Item Name: Quick Release Basket and Long Cargo Tube Mounting Provisions, Fits LH or RH

DART SERVICE INSTRUCTION

TO AMEND INSTALLATION INSTRUCTIONS D350-607-3 Rev.D,
INSTALLATION INSTRUCTIONS D350-607-4 Rev. C AND
INSTRUCTIONS FOR CONTINUED AIRWORTHINESS ICA-D350-607 REV. 6
REF TCCA STC: SH94-14
REF FAA STC: SR00213NY
REF EASA STC: EASA.10016996
REF BRAZILIAN STC: 2007S03-03/-04/-05/-06

A	NEW ISSUE	AJS	14.05.16
REV.	DESCRIPTION	BY	DATE
DESIGN	AJS	DART AEROSPACE LTD HAWKESBURY, ONTARIO, CANADA	
DRAWN	AJS		
CHECKED	N/A	DRAWING NO.	REV. A
MFG. APPR.	N/A	DSI 9699	SHEET 1 OF 2
APPROVED		TITLE	SCALE
DE APPR.		LUG REPLACEMENT	NTS
DATE	14.05.16	COPYRIGHT © 2014 BY DART AEROSPACE LTD THIS DOCUMENT IS PRIVATE AND CONFIDENTIAL AND IS SUPPLIED ON THE EXPRESS CONDITION THAT IT IS NOT TO BE USED FOR ANY PURPOSE OR COPIED OR COMMUNICATED TO ANY OTHER PERSON WITHOUT WRITTEN PERMISSION FROM DART AEROSPACE LTD.

FIGURE 1: INSTALLATION OF D4775-041 FWD STRUT

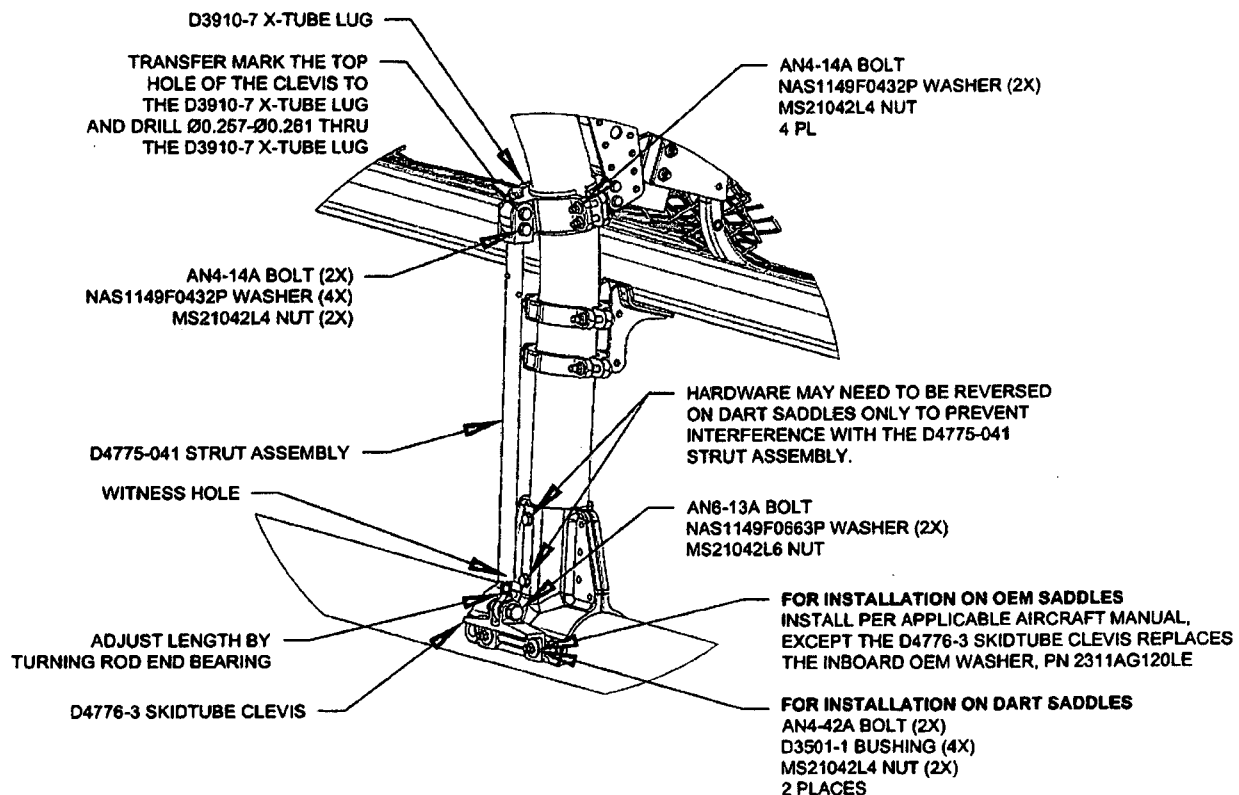
- 3.1 Substitute the Forward Lower D3910-5 X-Tube Lug with the D3910-7 X-Tube Lug as shown in Figure 1.
- 3.2 Install the forward D4775-041 Strut Assembly. Transfer mark from the upper hole on the clevis of the D4775-041 Strut Assembly to the D3910-7 X-tube Lug and drill thru the lug $\varnothing 0.257$ - $\varnothing 0.261$ as shown in Figure 1. Touch up chemical conversion coating per MIL-DTL-5541. Check the witness holes located at the bottom end of the D4775-041 Strut Assemblies to ensure that the thread from the rod end extends past the witness hole.
Torque MS21042L4/-4 nuts to 50-70 in-lbs (5.7-7.9 N-m). Torque MS21042L6/-6 nuts to 160-190 in-lbs (18.1-21.5 N-m).
- 3.3 Complete the installation in accordance with Installation Instructions D350-607-3 Rev. D or D350-607-4 Rev. C.
